REVISSED SITE DEVELOPMENT PLAN

WARFIELDS RANGE II
 SECTION 2 AREA 4
 LOTS 77 THRU 89

WARFIELDS RANGE II 10435 WHITE COURT STONE STRONG® RETAINING WALL SYSTEM

10435 WHITE COURT
 WARFIELDS RANGE II
 SECTION 2, AREA 4, LOT 85
COVER SHEET

10435 WHITE COURT
RETAINING WALL FINAL
WARFIELDS RANGE II
SECTION 2, AREA 4, LOT 85
PLAN

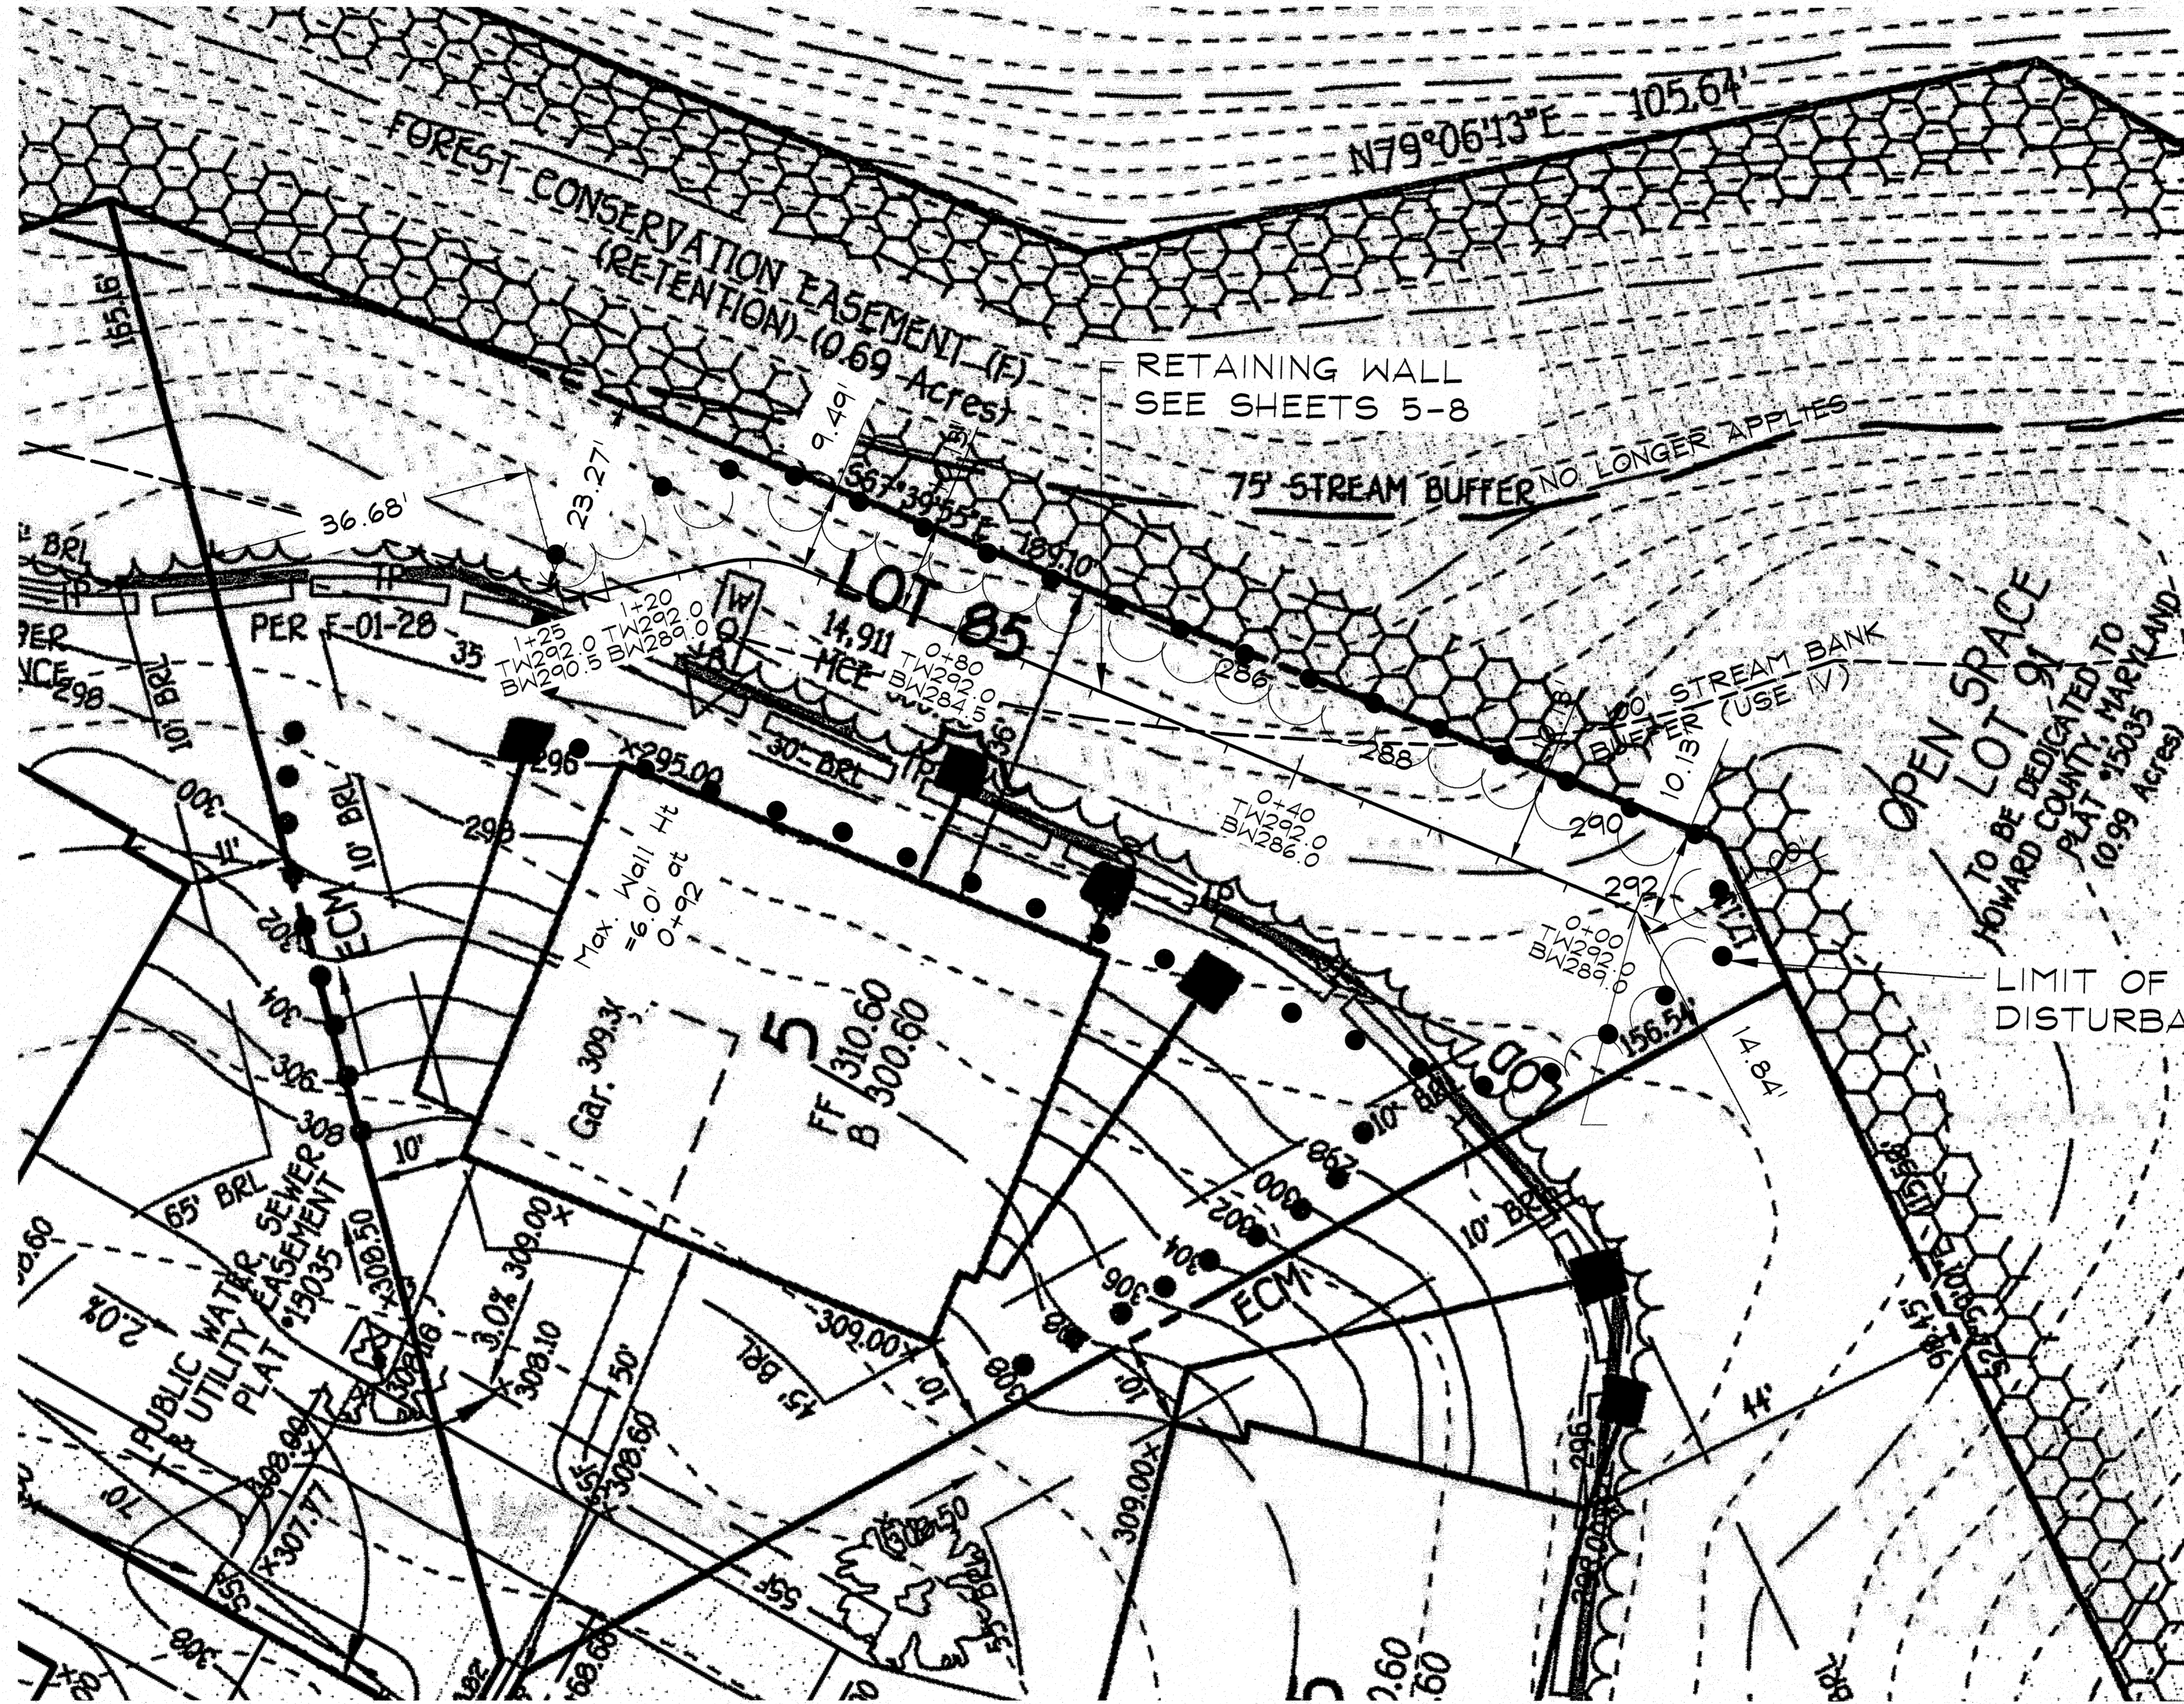
16. ALTERNATIVE COMPLIANCE APPROVAL (WP-22-048) WAS APPROVED ON JANUARY 27, 2022 WITH RESPECT TO SECTION 16.116(a)(2)(iii) OF THE SUBDIVISION AND LAND DEVELOPMENT REGULATIONS TO CONSTRUCT A 6' HIGH RETAINING WALL AND FENCE IN THE REAR YARD WITHIN THE 100' STREAM BANK BUFFER SUBJECT TO THE FOLLOWING CONDITIONS:

1. A redline revision to the Site Development Plan (SDP-02-087) shall be submitted to add the proposed retaining wall to the plan set. Structural computations shall be submitted with the redline as the height of the wall exceeds 3 feet. All proposed grading for the wall shall be shown and the Limit of Disturbance shall be identified. The redline revision shall be approved, changes drafted on the originals and the retaining wall sheets added to the plan set prior to issuance of a building permit for the proposed retaining wall. Refer to comments from the Development Engineering Division dated January 12, 2022.

5. The proposed retaining wall shall be constructed in the location shown on the alternative compliance plan exhibit. The height of the wall cannot exceed 6 feet within the 10' rear setback for accessory structures in accordance with Sections 108.0.D.4 and 128.0.A.9 of the Zoning Regulations.

10435 WHITE COURT
RETAINING WALL FINAL
WARFIELDS RANGE II
SECTION 2, AREA 4, LOT 85
LANDSCAPE PLAN
6TH ELECTION DISTRICT HOWARD COUNTY MD

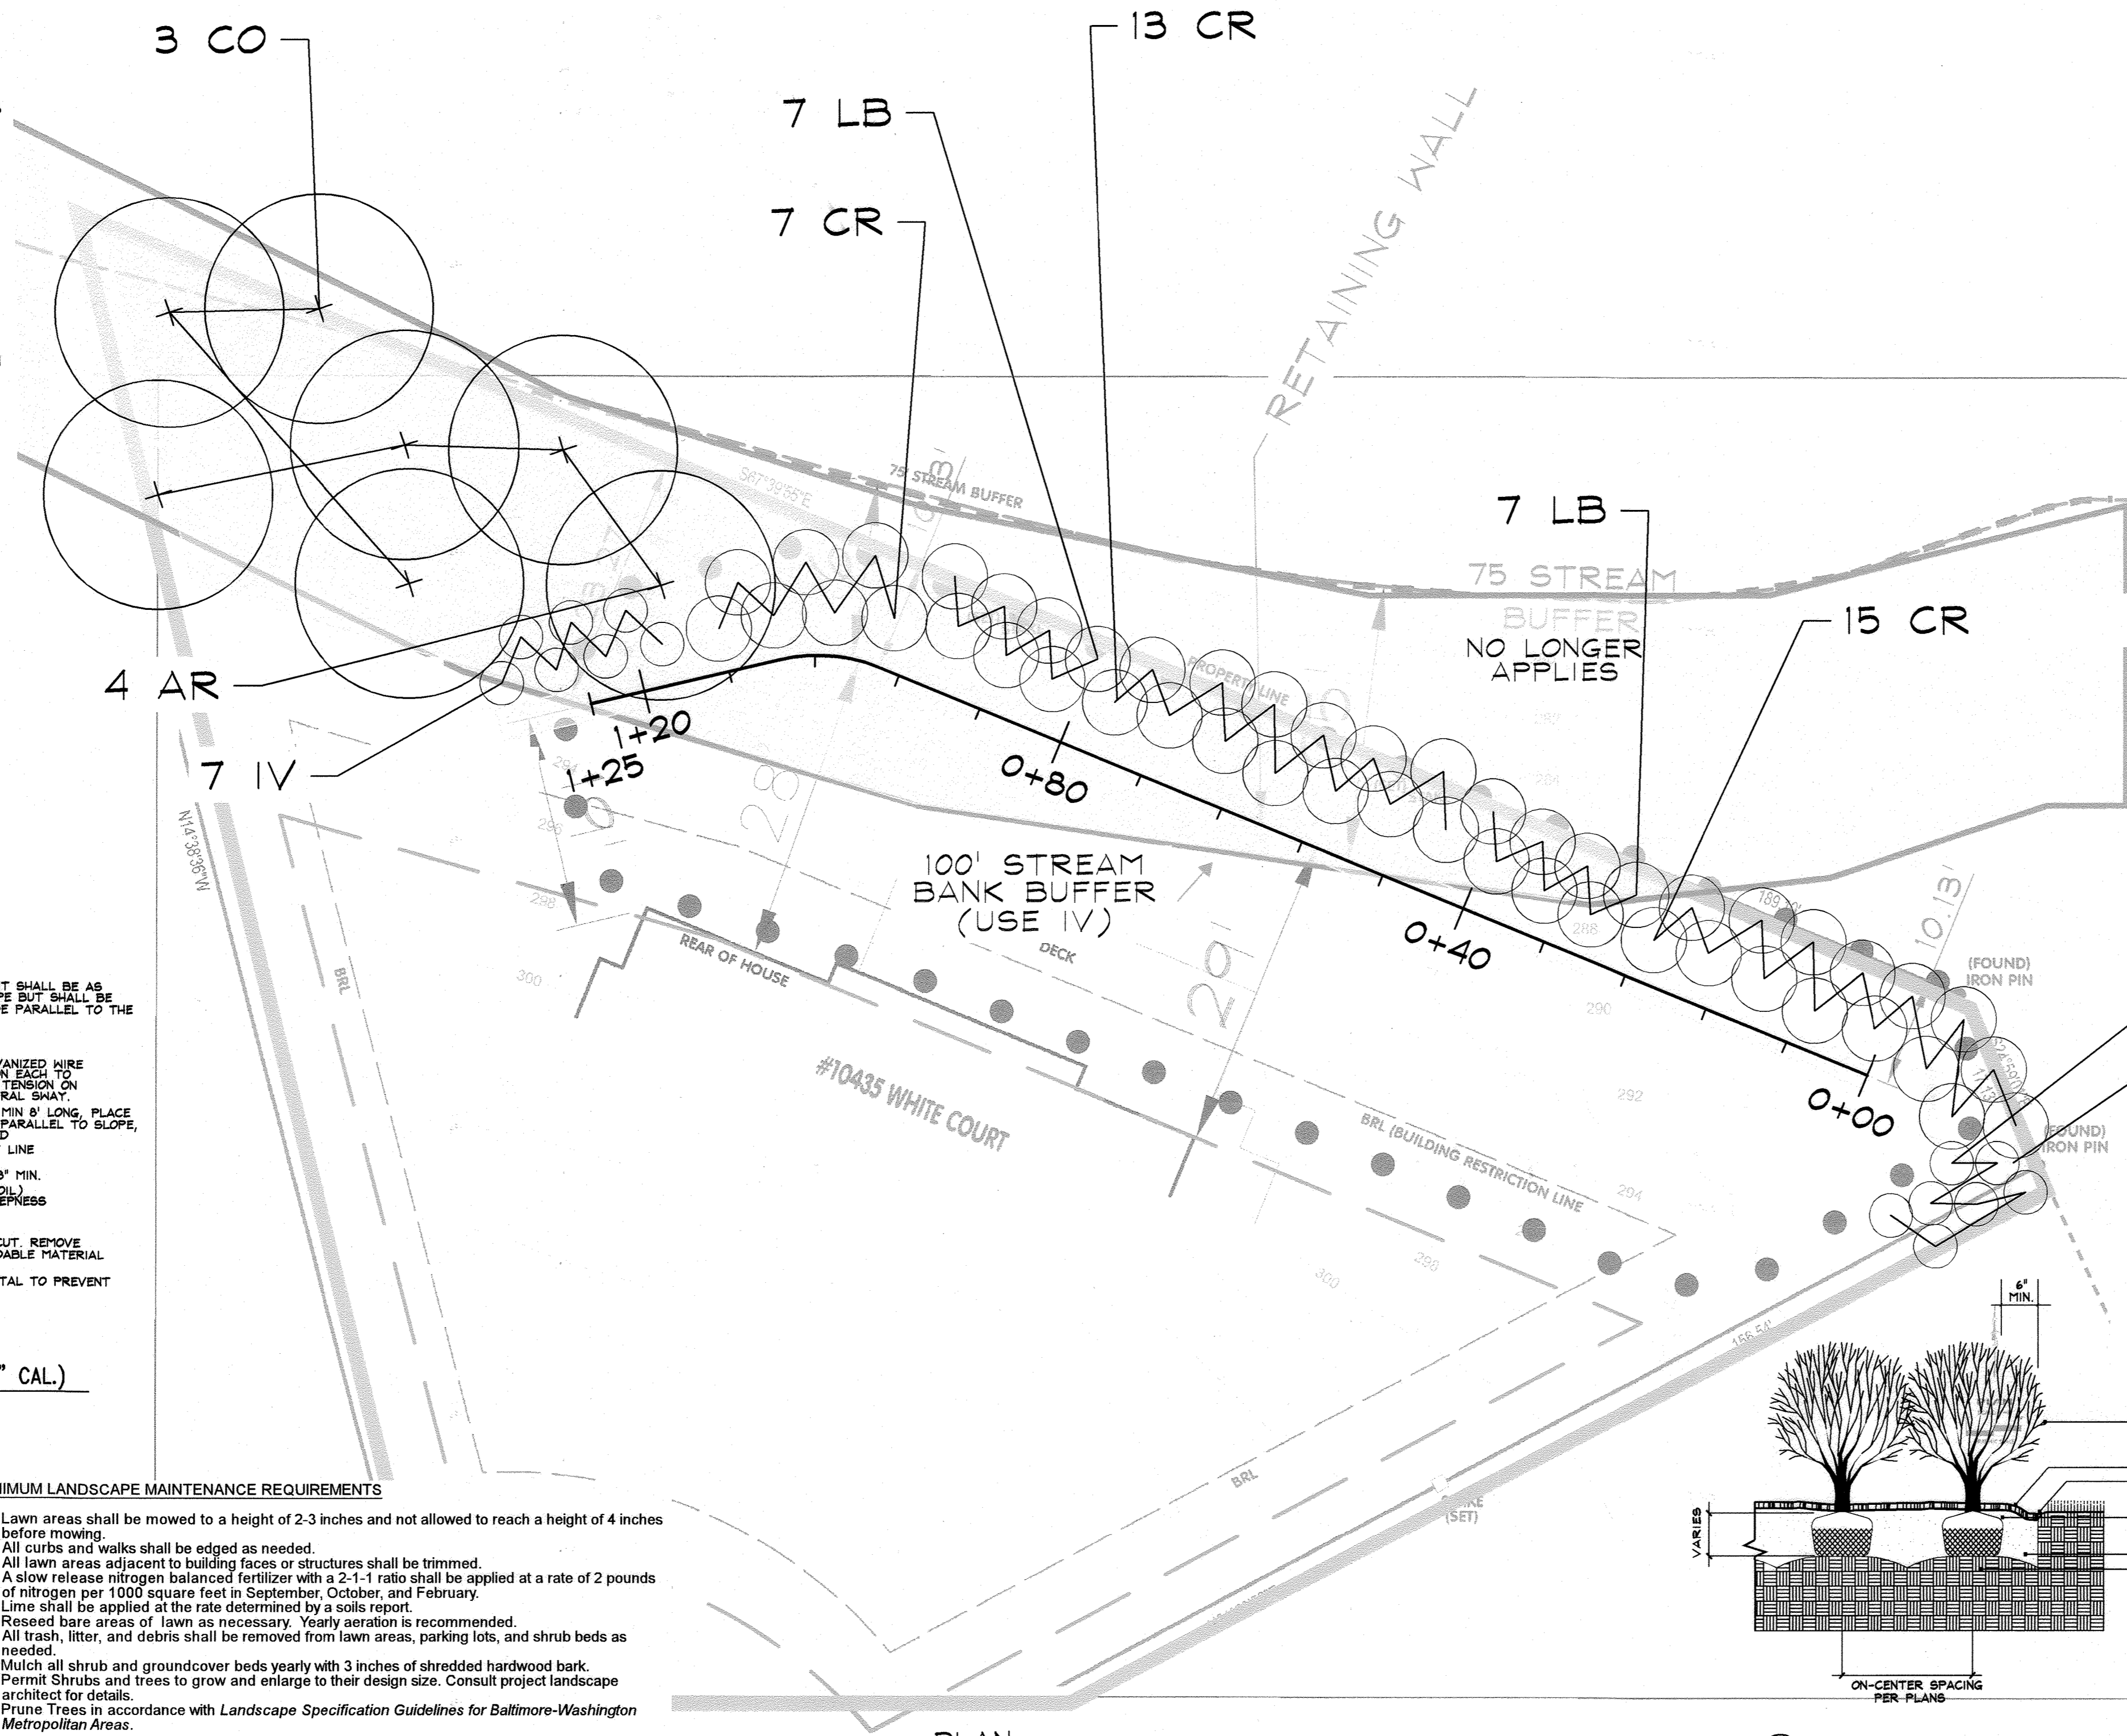
ALTERNATIVE COMPLIANCE APPROVAL (WP-22-048) WAS APPROVED ON JANUARY 27, 2022 WITH RESPECT TO SECTION 16.116(a)(2)(iii) OF THE SUBDIVISION AND LAND DEVELOPMENT REGULATIONS TO CONSTRUCT A 6' HIGH RETAINING WALL AND FENCE IN THE REAR YARD WITHIN THE 100' STREAM BANK BUFFER SUBJECT TO THE FOLLOWING CONDITIONS:

2. The applicant shall plant a minimum of 7 native shade trees at least 2-inch caliper onsite within the 100' stream bank buffer. The locations, species and planting specifications (including deer protection) shall be included in the redline revision to SDP-02-087.

3. Native shrubs shall be planted at the base of the retaining wall between the drain outfalls and the rear property line to prevent erosion within the stream buffer. The locations, species and planting and maintenance specifications (including deer protection) shall be included in the redline revision to SDP-02-087.
